**Errata to
Thermal Guidelines for Data Processing Environments
3rd Edition**

September 6, 2012

Figure 2.6 Server power increase (Class A3 is an estimate) versus ambient temperature for Classes A2 and A3.

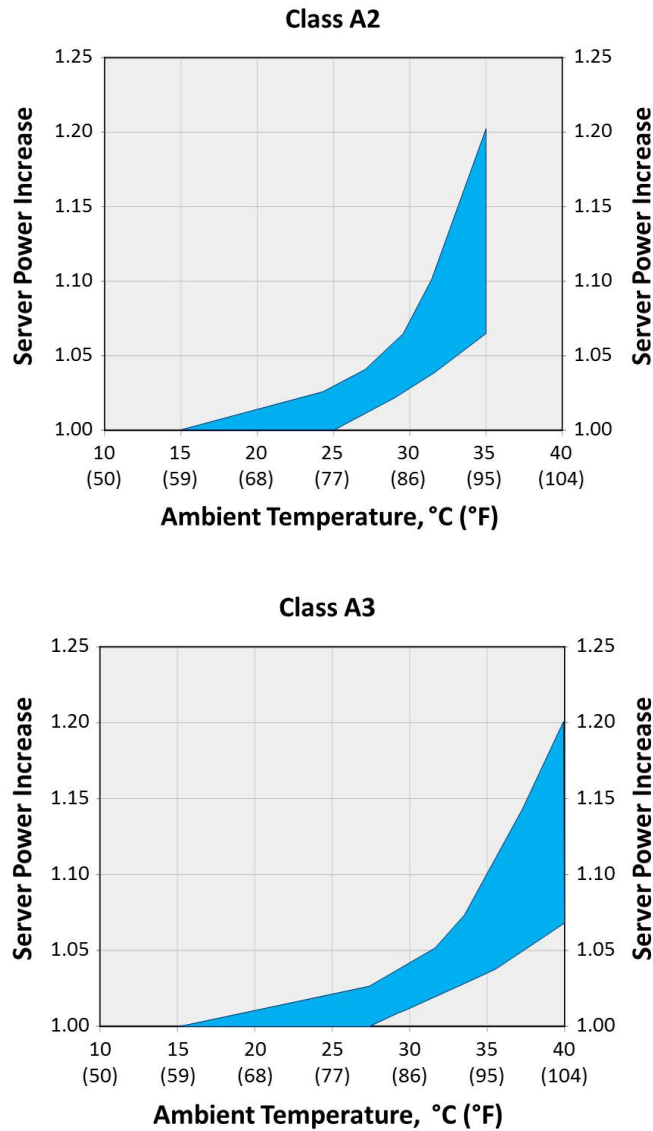
Page 25: Replace Figure 2.6 with the following (no change to caption):

Figure 2.7 Server flow rate increase versus ambient temperature increase.

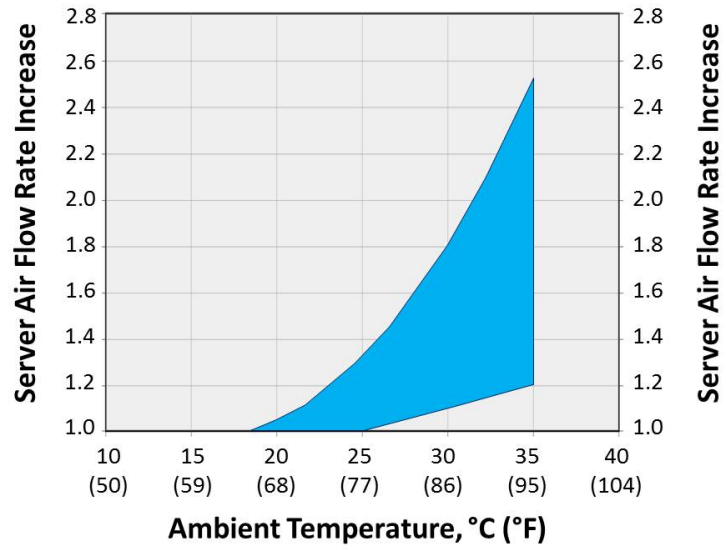
Replace Figure 2.7 with the following (no change to caption):
